# UNITED STATES PATENT AND TRADEMARK OFFICE

<b>Office Action Summary</b>	<b>Application No.</b>	<b>Applicant(s)</b>	
	10/698,091	WORRELL ET AL.	
	Examiner Troy Chambers	Art Unit 3641

## DETAILED ACTION

*Fig. 2*

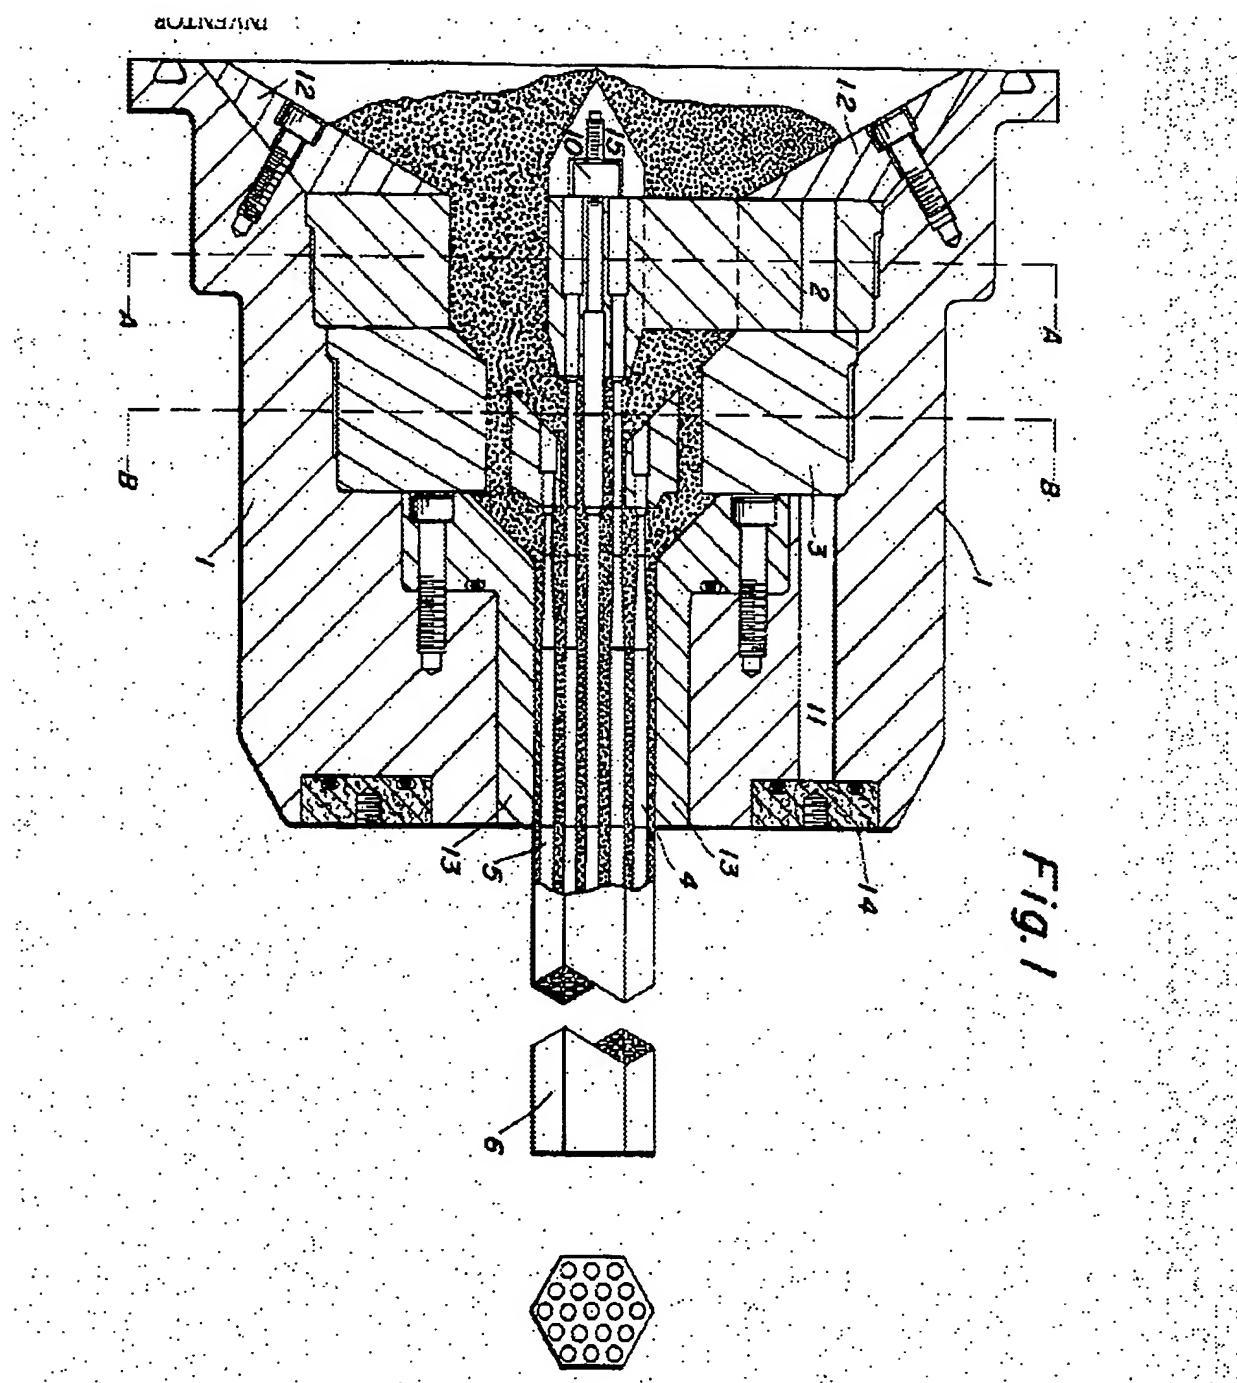
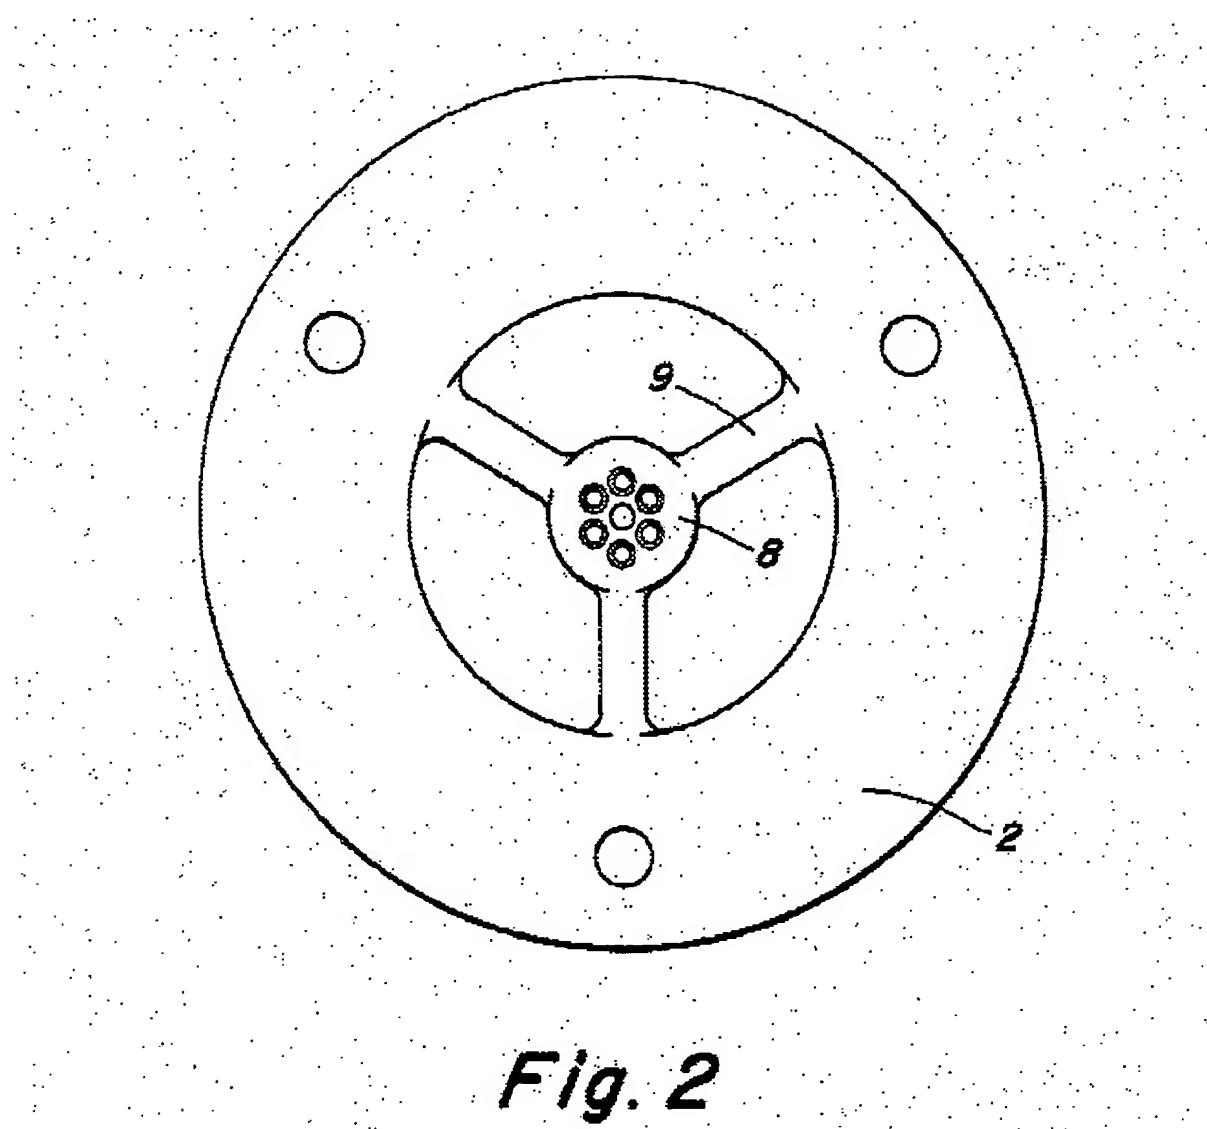
2. Claims 1-7 and 13-15 are rejected under 35 U.S.C. 102(b) as being clearly anticipated by US 3778217 issued to Bustamante et al.

4. Claim 10 is rejected under 35 U.S.C. 103(a) as being unpatentable over Bustamante. Bustamente discloses an extrusion die as shown above. However, Bustamente does not disclose a pin shape that is non-round. At the time of the invention, it would have been obvious to one having ordinary skill in the art to make the pins of Bustamente to be non-round since it has been held that such changes are a matter of design choice. In re Dailey, 357 F.2d 669, 149 USPQ 47 (CCPA 1966) (The court held that the configuration of the claimed disposable plastic nursing container was a matter of choice which a person of ordinary skill in the art would have found obvious absent persuasive evidence that the particular configuration of the claimed container was significant.) Moreover, the applicant's specification did not mention that such a shape is critical to the operation of the invention.
